Burwood Council Meeting

Tuesday 21 May 2024

Landowner Submissions – Urban Design Review

Burwood North Masterplan

Figure 10 - Requested changes to FSR from submission

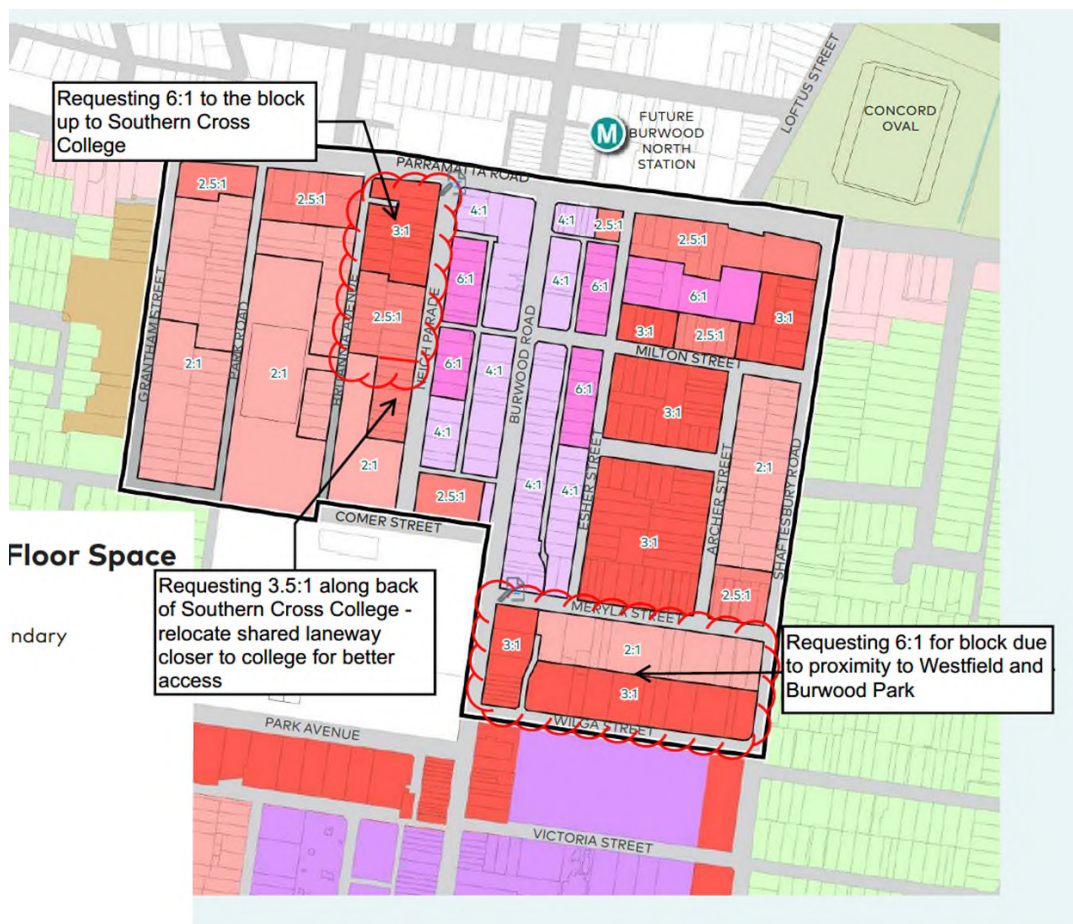
- Seeks an increase in FSR for block between Britannia Avenue and Neich Parade (from 2.5:1 and 3:1 to 3.5:1 and 6:1) to incentivise large amalgamations patterns to create larger developments and minimise smaller multiple developments especially in streets with homes on small land sizes. The setbacks proposed in the Masterplan will affect the development of these properties because of their small land size.
- Suggests relocating proposed cycleway to the boundary of Southern Cross College which will create easier access and better use for future residents and the college. Proposed location is close to the proposed cycleway in Britannia Lane.
- Seeks an increase in FSR for block between Meryla and Wilga Streets (from 2:1 and 3:1 to 6:1 FSR) due to proximity to Westfields and Burwood Park to incentivise redevelopment of older flats.

- Post-exhibition amendments to explore an increase in the FSR up to 3:1 between Britannia Ave and Neich Parade.
- Post-exhibition amendments to explore an increase in height to 35m (10 storeys) to sites fronting Neich Pde to allow development on wider lots. Height to remain consistent with the exhibited Masterplan at 28m (8 storeys) on Britannia Ave where narrower north-south orientated sites allow for more efficient site planning.

Figure 27 - Indicative Burwood North precinct layout and built form envelope approved under Stage 3 CSSI for Sydney Metro West Rail infrastructure, stations, precincts and operations (SSI-22765520)

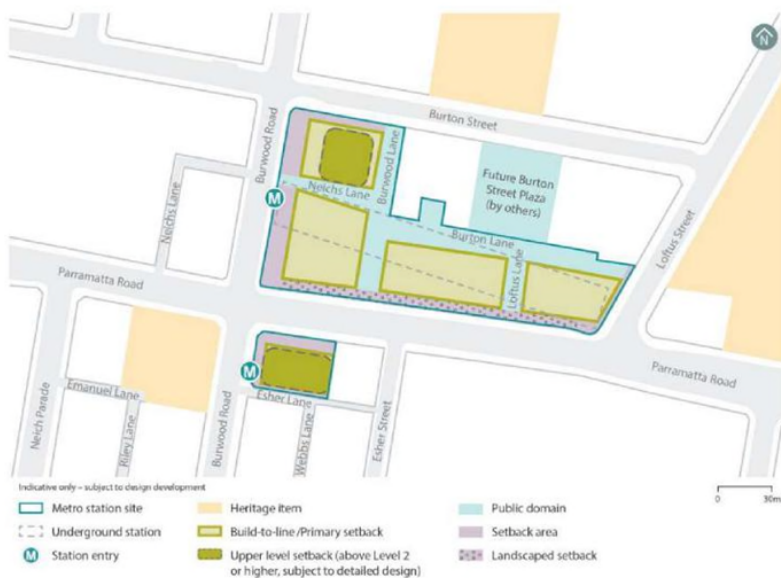
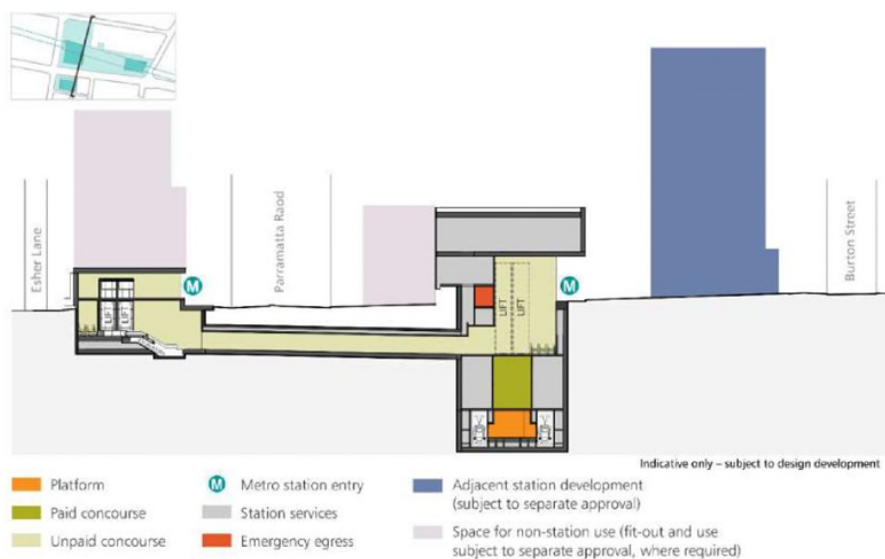
- The draft Masterplan proposes a 0m primary setbacks along all frontages and with a 3m and 6m upper level setback to Parramatta Road and Esher Lane respectively.
- Concern is raised with respect to the shared lane in Esher Lane as this will impede vehicular access to site.
- It is recommended to continue to collaborate with Sydney Metro to determine the appropriate built form typology and controls applying to the station site. Refer to Figure 27 for Stage 3 CSSI built form envelopes for the Sydney Metro West Burwood North precinct.

- Post-exhibition amendments to consider an increase up to FSR 6:1 and HOB to 65m similar to adjoining site.

Figure 30 - Extract from submission - Proposed envelope conceptual site massing for Nos.336-336A Parramatta Road (Source: Tony Owen).

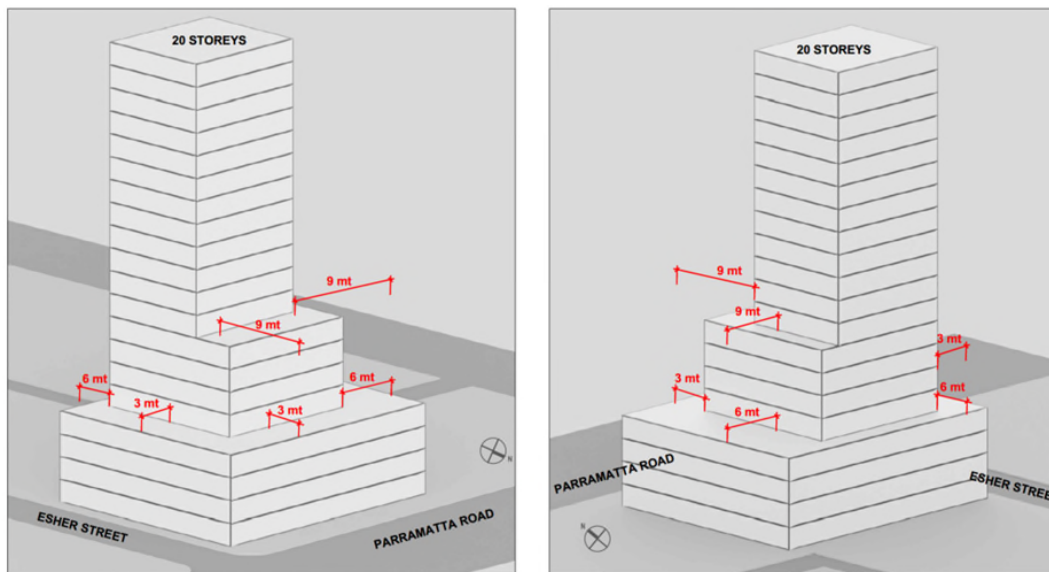
- Under the draft masterplan, this site and the adjoining Metro Station site have been identified in the land use diagram in Figure 66 of the draft Masterplan, for commercial use. The site is located to the north of proposed open space on Esher Street. The draft HOB and FSR for this site reflect the solar access needs of the proposed open space to the south of Esher Lane. The setbacks diagrams (Figure 73 and 74) of the draft Masterplan indicate a pedestrian through-site link from Esher Lane to Parramatta Road on the subject site, however this is not reflected in the any other diagrams.

Figure 45 - Extract from submission 17-23 Esher Street – Proposal to increase to 23 storeys (Source: Hatch)

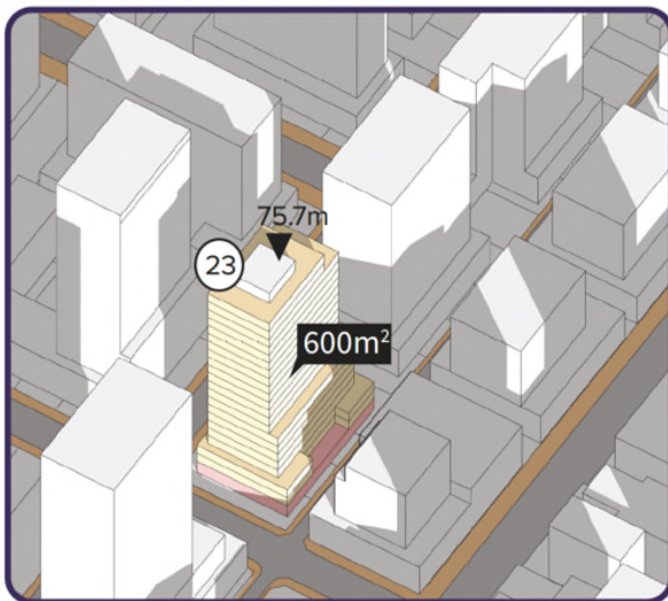
RECOMMENDED BUILDING ENVELOPE FOR THE SITE REFLECTING AN FSR OF 7.2:1 AND HEIGHT LIMIT OF 23 STOREYS (76.0M)

Figure 72 - Extract from submission – Proposed FSR

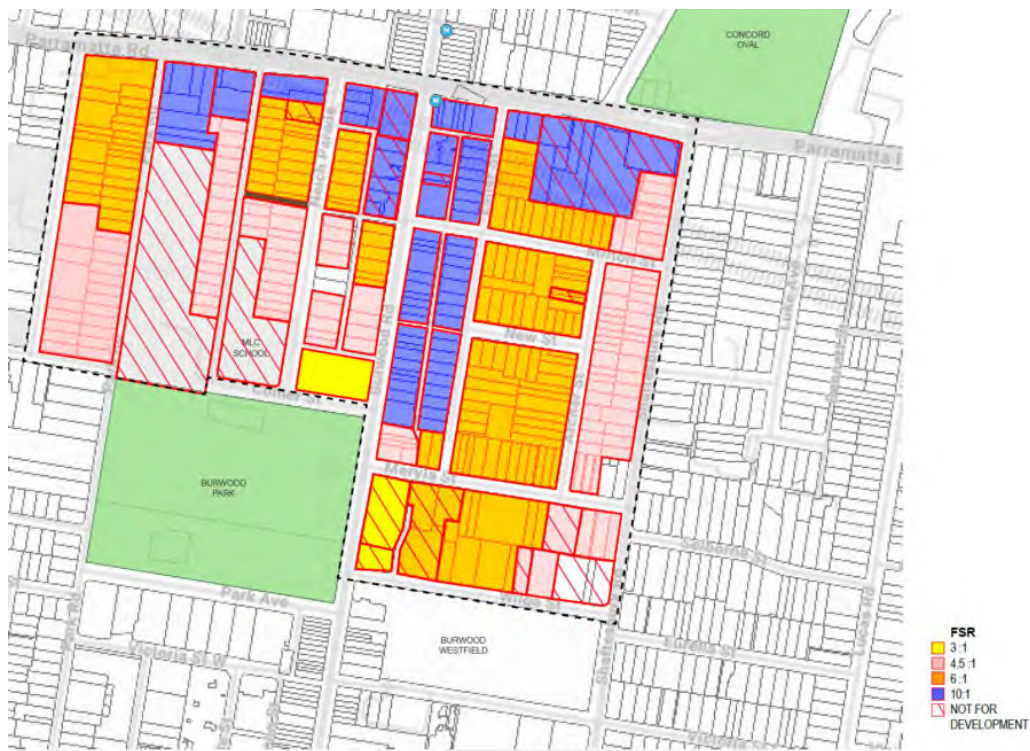
- Submission received proposing an alternative masterplan scheme for Burwood North study area indicating that the proposed controls developed by Council were not viable in the current market.
